United Village

Appeal of Planning Commission Decisions
Related to
Hotel and Parking Garage Project

April 10, 2024 - City Council Meeting

Zoning File #24-022-766

Variance #3 – Entrance Drive along University

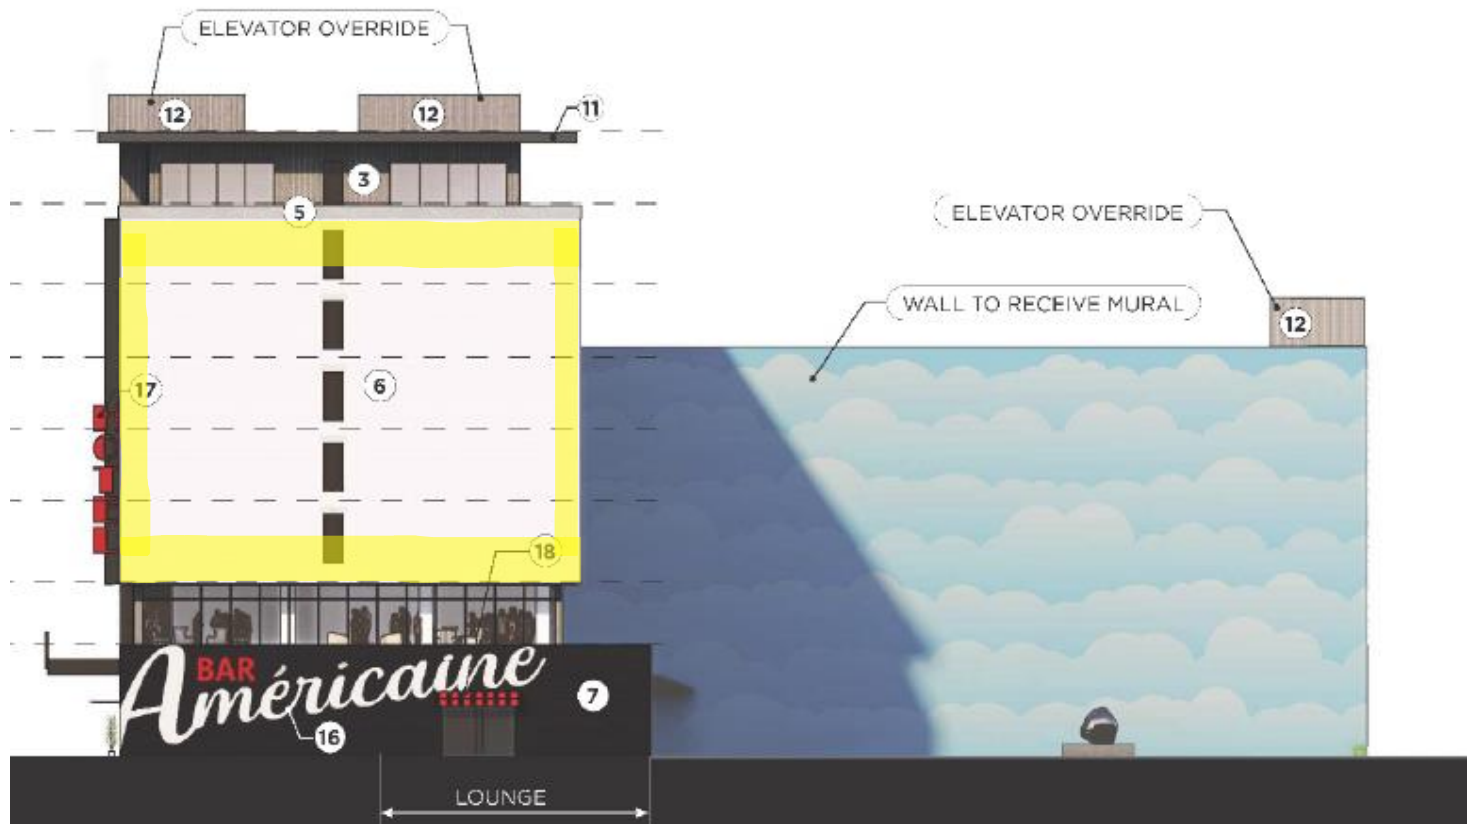
- Zoning Code limits driveway to 60' of lot frontage and 322' proposed for a variance of 262'
- Controlled access
- Utility boxes on University
- Side street access
- One-way westbound
- Drop-off/pick up lane
- Bypass lane
- No parking/No Not Enter Signs

- a) Entrance drive is vehicle-focused and does not provide safe and efficient circulation of all modes of transportation, including transit, pedestrian and bicycle traffic and is not in harmony with the Zoning Code.
- b) Entrance drive is contrary to comprehensive plan policies that call for: 1) focus on pedestrians, bicyclists, and transit; 2) high quality pedestrian urban design; 3) pedestrian-friendly streetscapes.
- c) Decision to site the driveway parallel to University Avenue is a choice made by the applicant and does not constitute a practical difficulty.

- a) Direct access from University is not allowed, the driveway is in harmony with the zoning code intent of ensuring convenience of access to property
- b) Comprehensive plan policies call for 1) minimizing and consolidating curb cuts and using side street access and 2) high-quality urban design that supports pedestrian friendliness and enhances the public realm
- c) Access management from county and city policies create practical difficulties as does presence of utility boxes along University

2. The United Village Final Plat shall be approved by the City Council and recorded with the county recorder and/or registrar of titles.
3. The driveway shall be for **one-way westbound** traffic only. Signage shall be installed indicating that **no parking** is permitted in the driveway and that the driveway is for check-in/check-out, pick-up/drop-off, and valet only. Signage shall indicate stopping in the bypass lane is prohibited.

4. The driveway shall be for **passenger vehicles** only as the site design cannot accommodate turning movements for larger vehicles.
5. There shall be a **direct pedestrian connection** between the sidewalk along University Avenue and the primary hotel entrance. The connection shall be reviewed and approved by Public Works.

6. There shall be a **landscape buffer** between the sidewalk along University Avenue and the driveway.
7. There shall be a **sidewalk width of 18'** along University Avenue.

8. The **owner/operator is solely responsible for ensuring the driveway operates in a safe manner for all users and does not result in adverse impacts to the public road system**. If the owner/operator is unable to manage the driveway in a safe manner that avoids adverse impacts to the public road system the City reserves the right to require closure of the driveway access points at the cost of the owner/operator. The owner/operator must at all times maintain an operating plan for the driveway and must provide it to the City upon request. This initial plan must be reviewed and approved by the Public Works Traffic Engineer during site plan review. Specifics to be addressed shall include: 1) document protocols, enforcement, and signage to limit the driveway to passenger vehicles, to manage the bypass lane, to prohibit parking and ultimately to assure no adverse impacts to the public road system; 2) quantify driveway use, frequency, volume, and peak times, etc.; 3) document how Metro Mobility, delivery vehicles, limousines, buses etc. will be accommodated and serve the site without adversely impacting the public road system.

Variance #5 - West Wall of Hotel Portion of Building

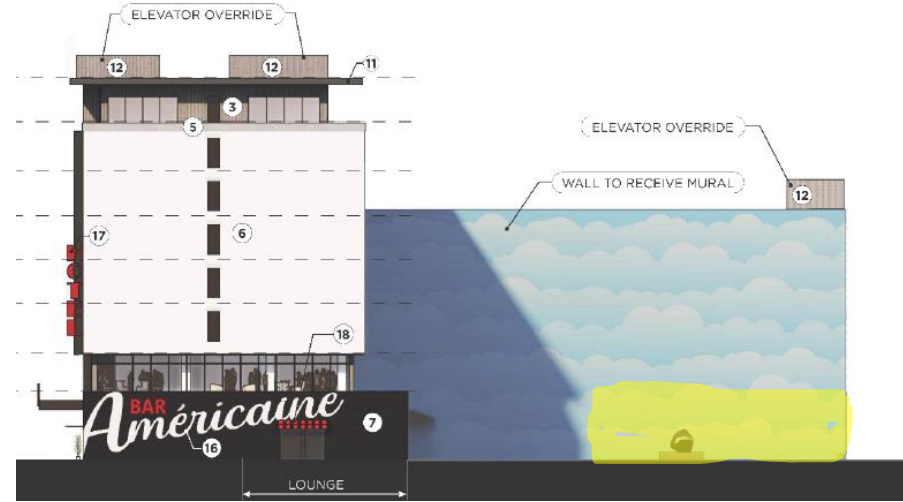
Variance #5 Conditions – Windows on West Wall of Hotel

1. Final plans approved by the Zoning Administrator for this use shall be in substantial compliance with the plans submitted and approved as part of this application.
2. The United Village Final Plat shall be approved by the City Council and recorded with the county recorder and/or registrar of titles.
3. A wall graphic and lighting shall be installed on the west façade of the hotel portion of the building; this façade shall be lit at dusk.
4. A mural shall be installed on the west façade of the parking garage portion of the building within one year of the issuance of the certificate of occupancy. The mural shall be lit at dusk.
5. **Additional openings shall be added to the west façade of the hotel building on floors 3 through 7.**
